CITY OF ALBUQUERQUE

RE: **Blakes Lotaburger**
1640 Gibson Blvd SE
Revised Grading and Drainage Plan
Engineer's Stamp Date 7/24/17 (File: M15D012A)

Based upon the information provided in your submittal received 7/24/17, the Revised Grading and Drainage Plan is approved for Grading and Building Permit.

PROJECT TITLE BLAKE'S LOTABURGER 1640 GIBSON BLVD. SE ALBUQUERQUE, NEW MEXICO 87106	DRAWN BY: JEFF WOOTEN
PROJECT MANAGER JEFF WOOTEN	SHEET TITLE Grading Plan
JOB NO. 2016033	DATE 7/24/2017
SCALE AS NOTED	SHEET NO. C1.1

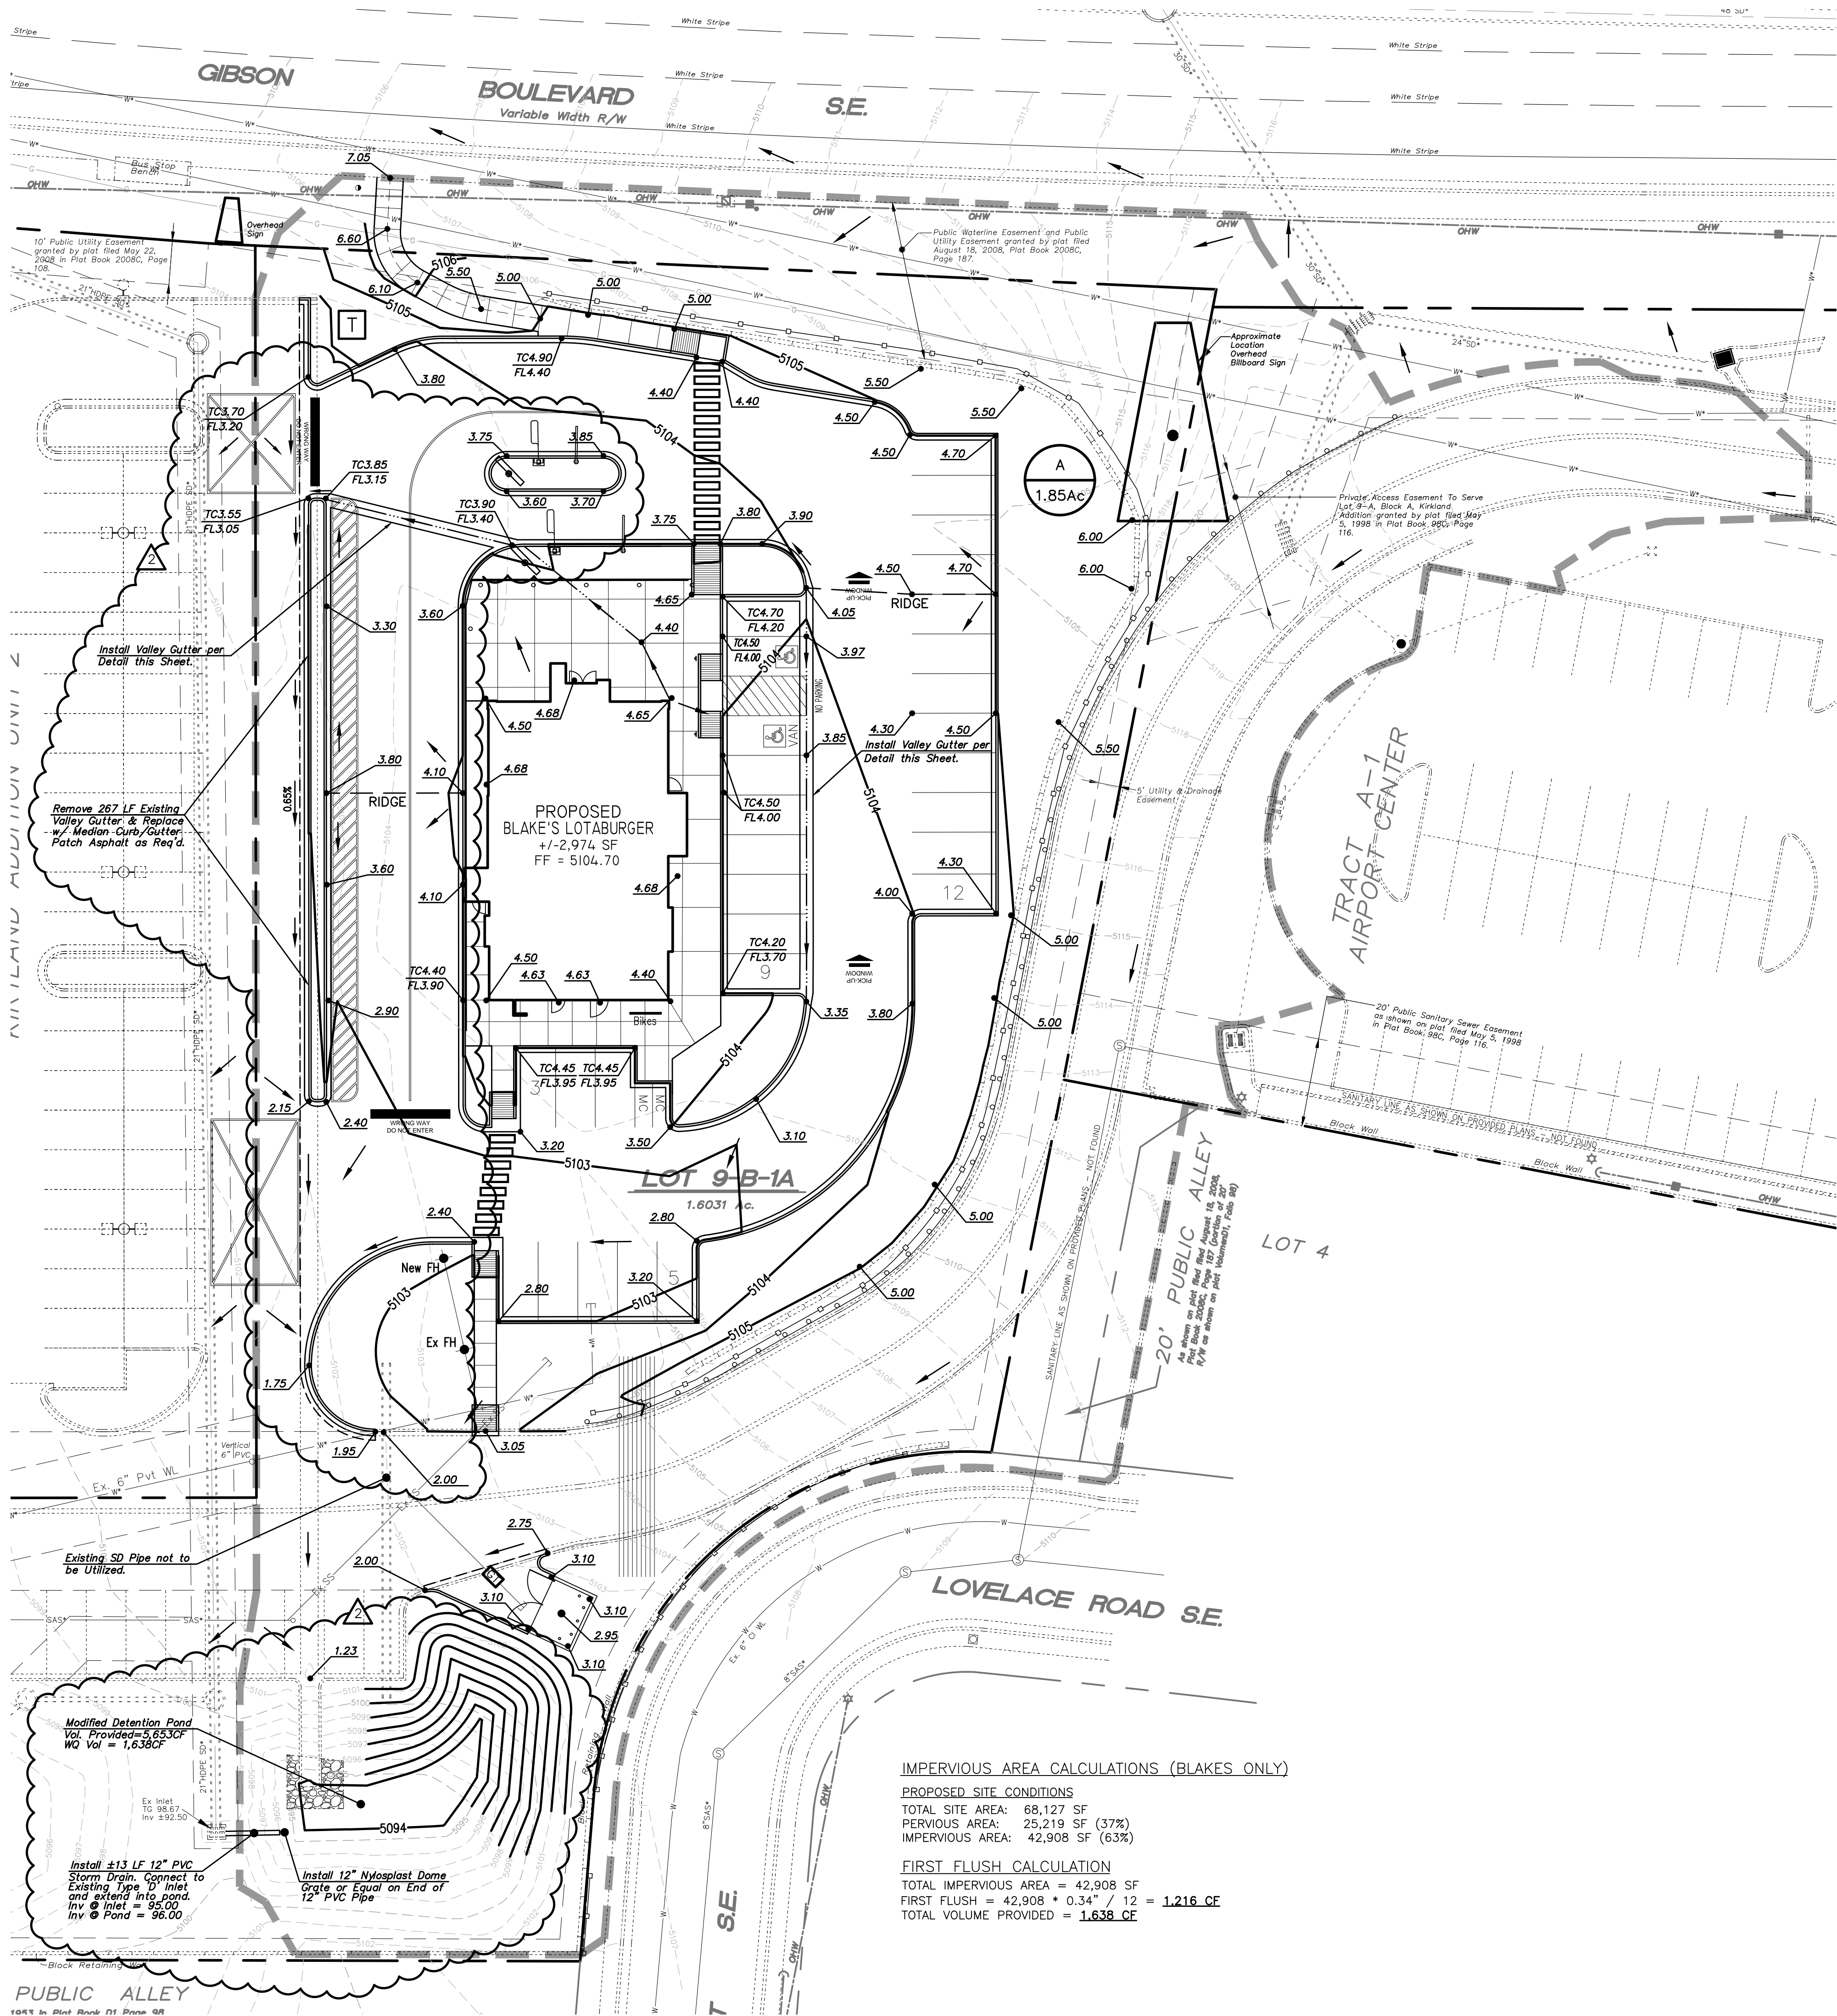
The enlarged south pond with additional dead storage is an acceptable modification, but will need to be surveyed, as-built, and the constructed volume certified as part of the Engineer's Drainage Certification.
